# HISTORIC AND DESIGN REVIEW COMMISSION

March 17, 2021

**HDRC CASE NO:** 2021-100  
**ADDRESS:** 415 MISSION ST  
**LEGAL DESCRIPTION:** NCB 946 BLK 2 LOT 22  
**ZONING:** RM-4 H HS  
**CITY COUNCIL DIST.:** 1  
**DISTRICT:** King William Historic District  
**LANDMARK:** Individual Landmark  
**APPLICANT:** Fernando De Leon/One Stop Code Consulting  
**OWNER:** Jake Jazdzewski/JAZDZEWSKI JAKE & MONICA  
**TYPE OF WORK:** Relocation and exterior modifications to rear accessory structure  
**APPLICATION RECEIVED:** February 22, 2021  
**60-DAY REVIEW:** Not applicable due to City Council Emergency Orders  
**CASE MANAGER:** Stephanie Phillips  
**REQUEST:**

The applicant is requesting conceptual approval to:

6 RIGHT ELEVATION - NEW IMPROVEMENTS  
A5 SCALE: 1/4" = 1'-0"

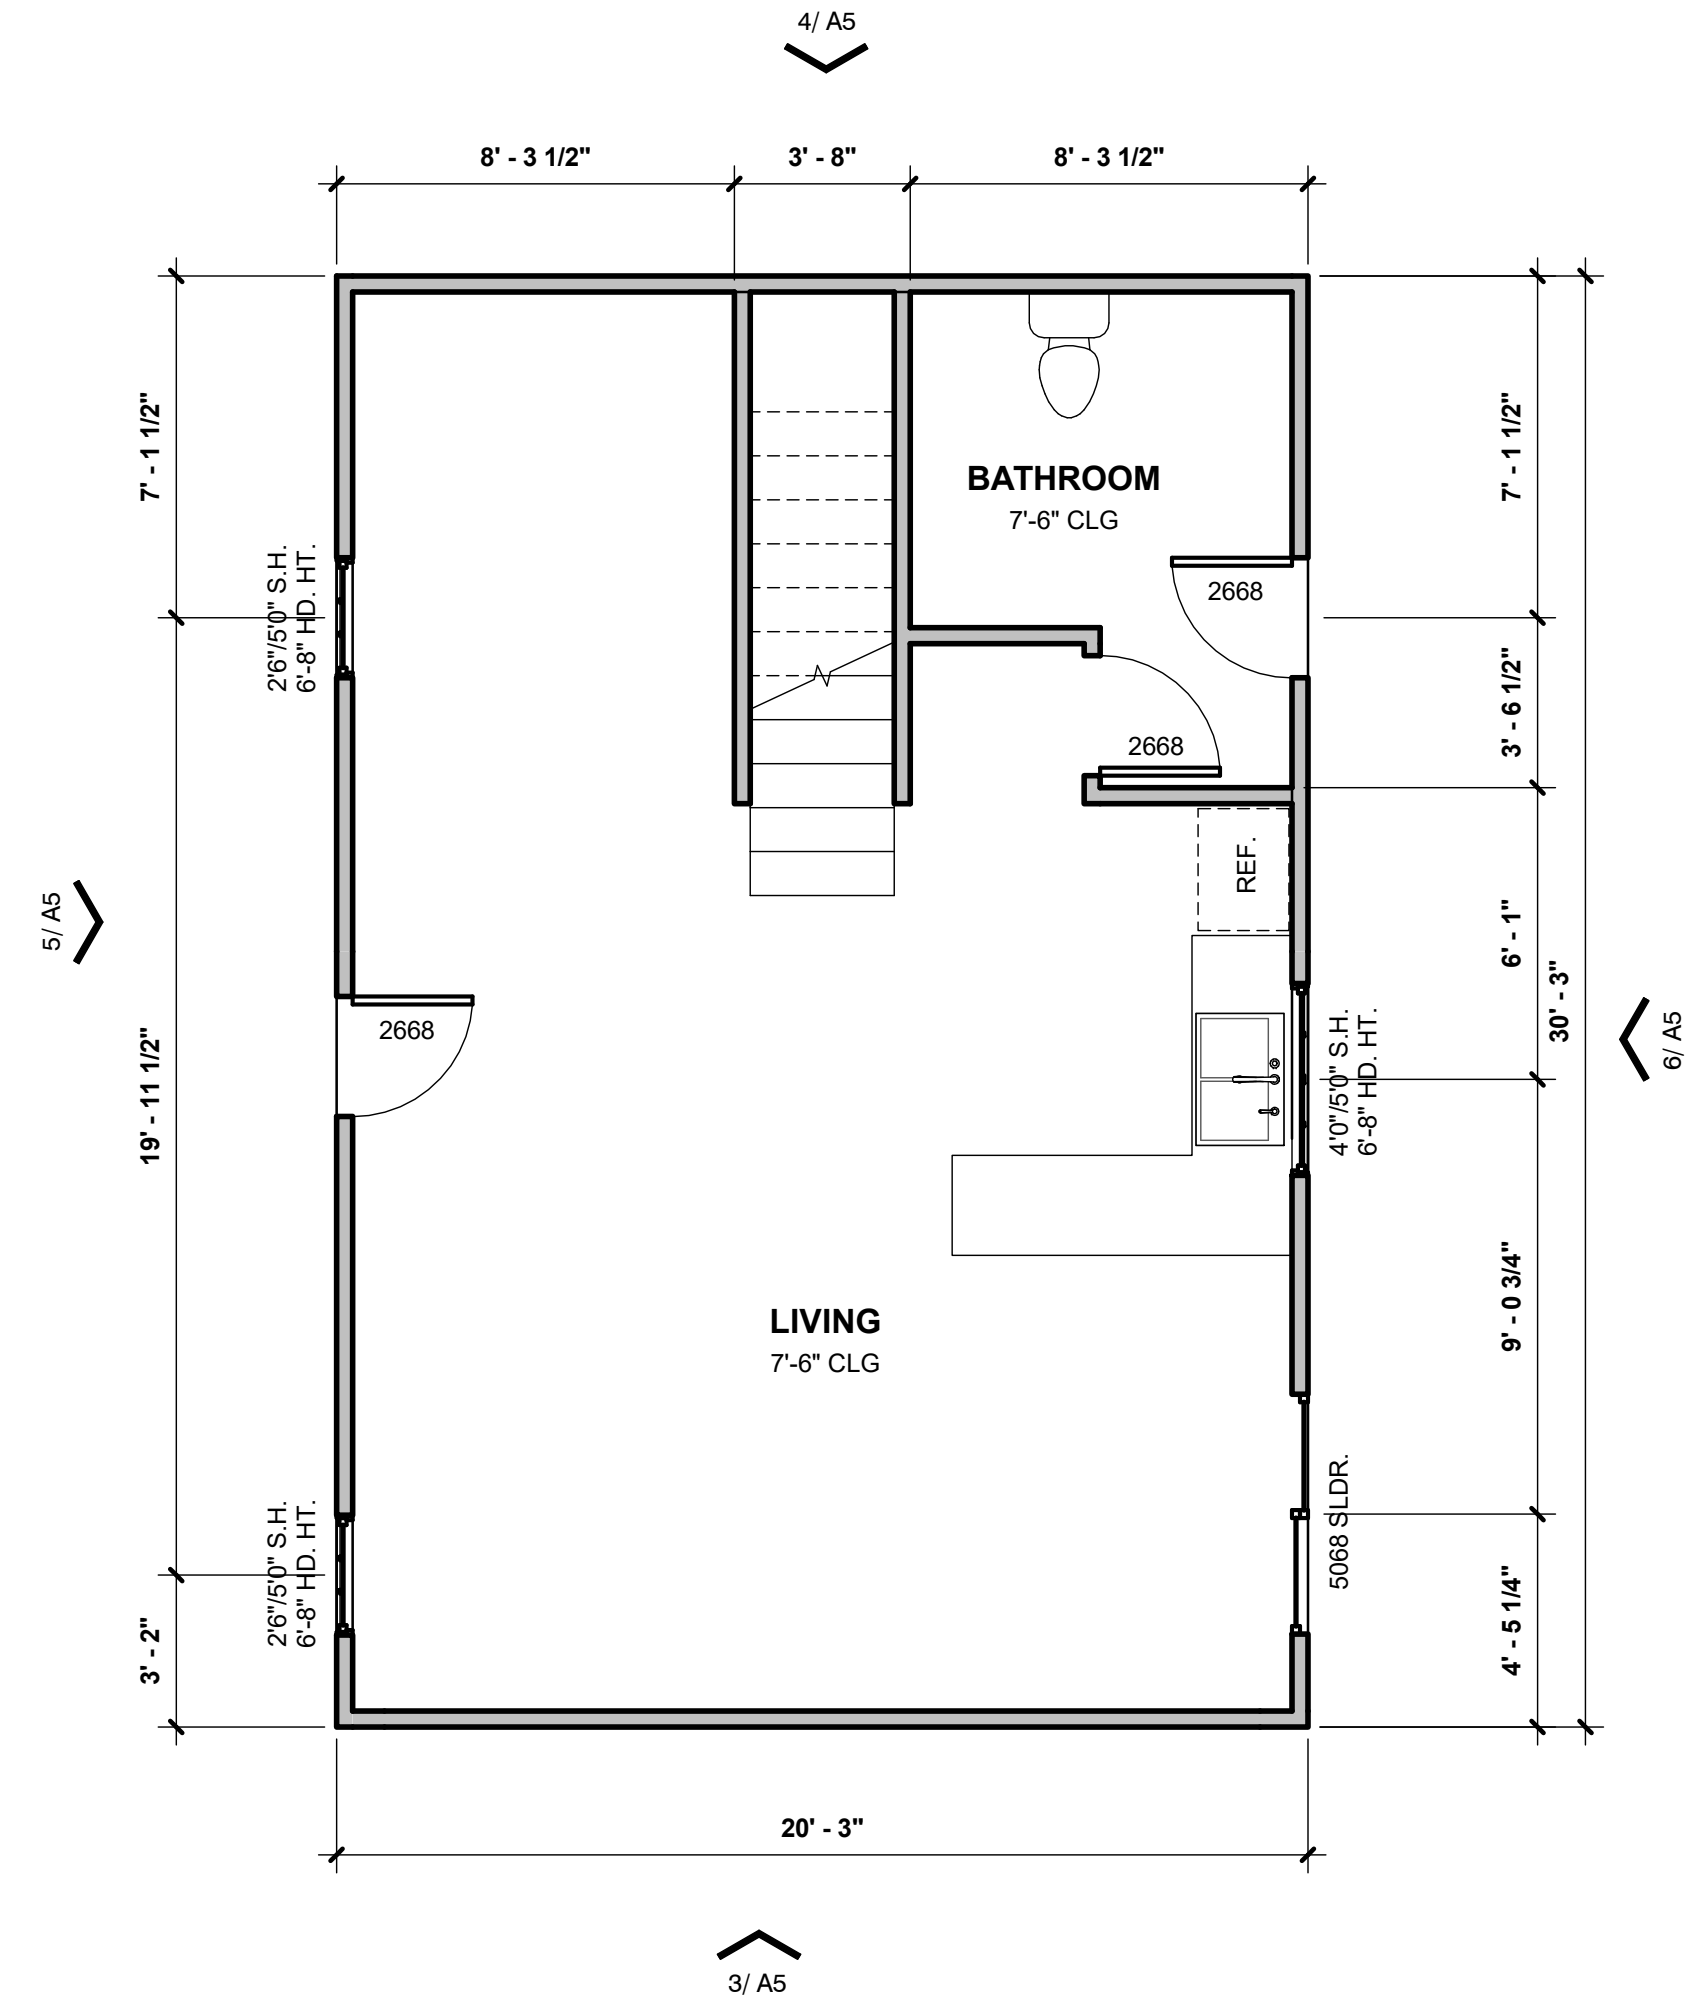
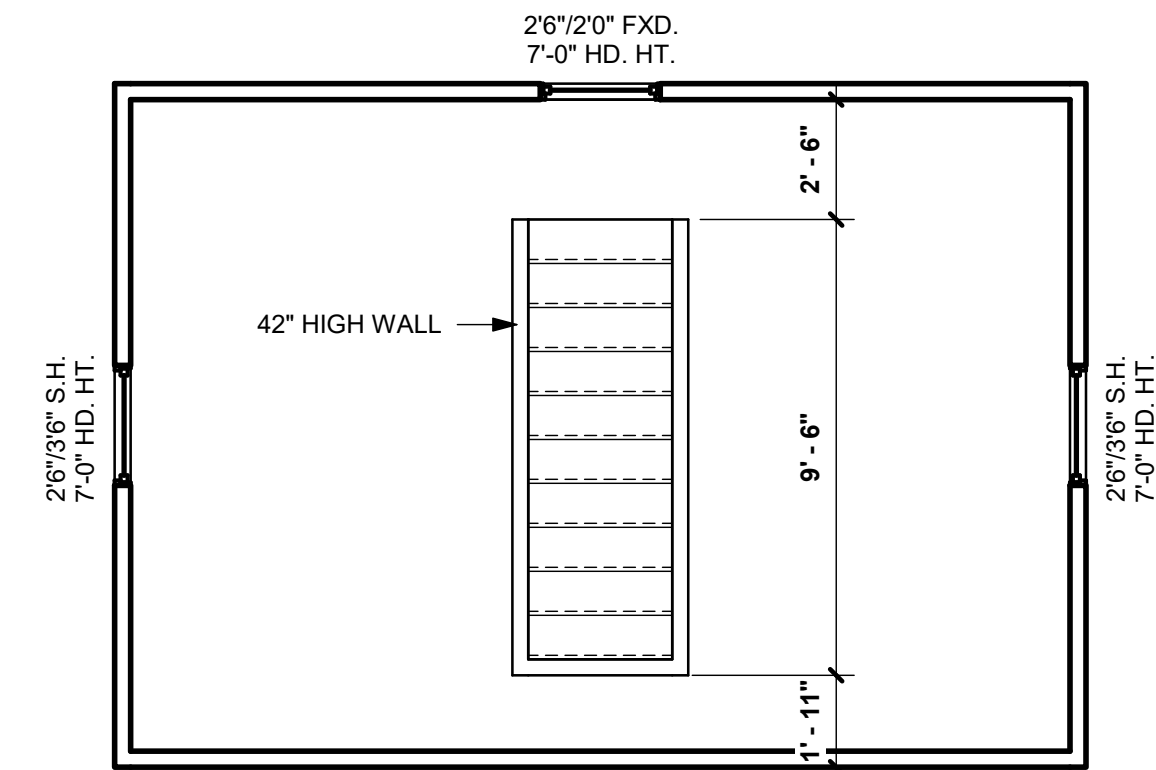
- e. **FENESTRATION MODIFICATIONS** – The applicant has proposed to replace an existing second story door at the stair landing with a new window to match existing in terms of scale, proportion, configuration, and inset. The awning above the door will also be removed. Staff generally finds the request appropriate, but finds that the door should be retained and reused elsewhere on the structure, or stored on the property. Additionally, the applicant has proposed to remove an existing first floor window and enclose with siding on the back elevation. An existing second story window on this elevation will be retained. Staff generally finds the request acceptable based on its limited visibility from the public right-of-way and the retention of an additional opening, but finds that the window should be retained and reused elsewhere on the structure, or stored on the property. Staff also finds the addition of new sliding doors on an ancillary elevation to be appropriate.

- f. **GARAGE BAY ENCLOSURE** – The applicant has proposed to enclose the open garage bay with siding to create interior space. The garage is the single story mass of the rear accessory structure and faces the primary structure. The garage does not serve a driveway, rear alley, or other parking access or configuration and is located to the west of the driveway in the rear yard. Staff finds the enclosure of the garage bay acceptable due to its limited visibility from the public right-of-way and the fact that the remaining elements of the structure, including all walls, the front half circle window, and the vertical trim pieces, will be retained, rendering the intervention reversible.

- g. **WINDOW REPLACEMENT** – The applicant has proposed to replace all existing windows with new aluminum clad wood windows per the submittal documents. The applicant has not provided photographs of the existing window conditions. At this time, staff requires additional information to make an official determination on appropriateness, including a window schedule and photographs of the condition of each existing window. Staff recommends window

- i. That the applicant retains the existing windows and doors to be removed and reuses them in other openings on the structure, to include the replacement of windows deteriorated beyond repair if applicable, or keeps them onsite for future use as noted in findings e and f.

- ii. That the applicant submits a comprehensive window schedule and photographs of each window requested to be replaced for final approval to determine the appropriateness of window replacement as noted in finding h. Staff strongly encourages window repair and restoration wherever feasible, which is eligible for administrative approval.

- iv. That the applicant provides information on the proposed new siding to be used and all final material specifications for final approval.
